Technical Service Bulletin

15 Oil leak and/or camshaft DTCs stored - 3.0L

15 08 09 2005587/6 November 7, 2008. Supersedes Technical Service Bulletin Group 15 number 08-08 dated 2005587/5 for reasons listed below.

Model(s)	Year	VIN Range	Vehicle-Specific Equipment
A4	2002 – 2005	All	3.0L V6 Engine
A4 Cabriolet	2003 – 2006	All	
A6	2002 – 2004	All

Figure 1. The camshaft adjusters (A) and camshaft adjustment housings (B).

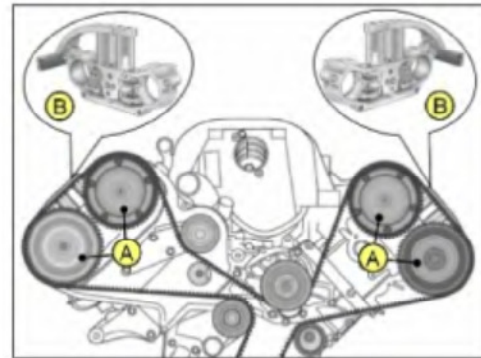
1. Check for a DTC for a camshaft position sensor (P0340 - P0348, P0365, P0368, P0390 - P0393).
Do not replace the camshaft adjusters (A) or the camshaft adjustment housings (B) if any camshaft position sensor DTC is present.

1. Do not replace the camshaft adjusters (Figure 1, A) or camshaft adjustment housings (Figure 1, B) because of these DTCs.
2. Follow Guided Fault Finding test plan for diagnosis.
3. Erase the DTC memory. These DTCs only occur during the break-in period of the cylinder head and are not causing the MIL.
4. Check for sufficient oil pressure. If the oil pressure is too low, also check for oil leaks from/around the camshaft adjusters.

Figure 2. The gasket (1), camshaft adjustment housing (B), camshaft sealing rings (2) and O-rings (3).

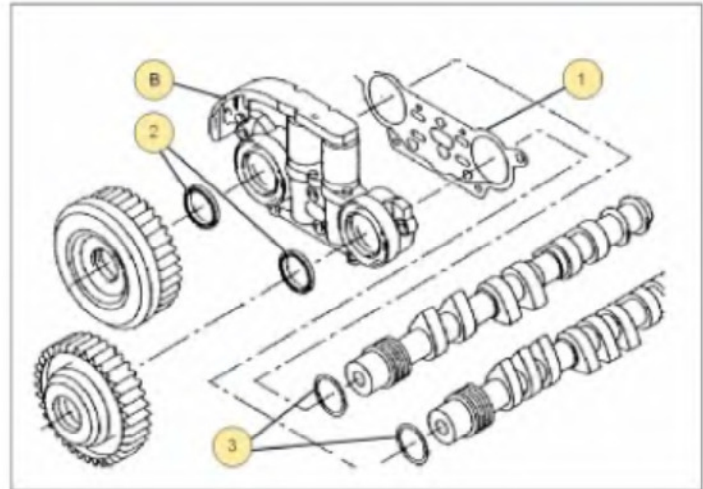
5. In case of an oil leak from a camshaft adjuster, perform the following repairs only on the affected side.

- a. Do not replace the camshaft adjusters (Figure 1, A) or camshaft adjustment housings (Figure 1, B)
- b. Replace gasket (Figure 2, 1) and O-rings (Figure 2, 3) between camshaft adjustment housing (Figure 2, B) and cylinder head.

Replace both camshaft sealing rings (Figure 2, 2) (See Repair Manual, Group 15, "Camshaft and camshaft adjusters, removing and installing")

Figure 3. The outer bolts (3), caps (4), and O-Rings (5).

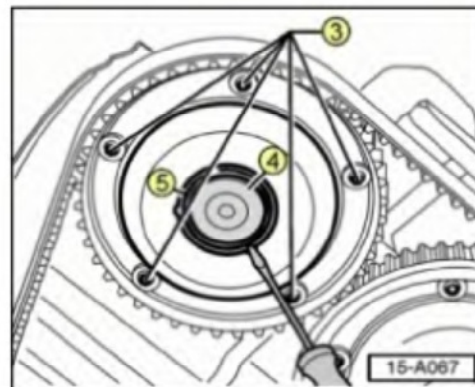
1. Retorque all five outer bolts (Figure 3, 3) on all four camshaft adjusters to 15 Nm. (The bolt heads are located on the back side of the camshaft adjuster gears.)
2. Replace missing or damaged bolts (part number WHT 003 121).
3. Replace caps (Figure 3, 4) and O-Rings (Figure 3, 5) and secure with securing ring (See Repair Manual, Group 15, "Camshaft and camshaft adjusters, removing and installing.")
4. Reassemble removed components and complete the repair.
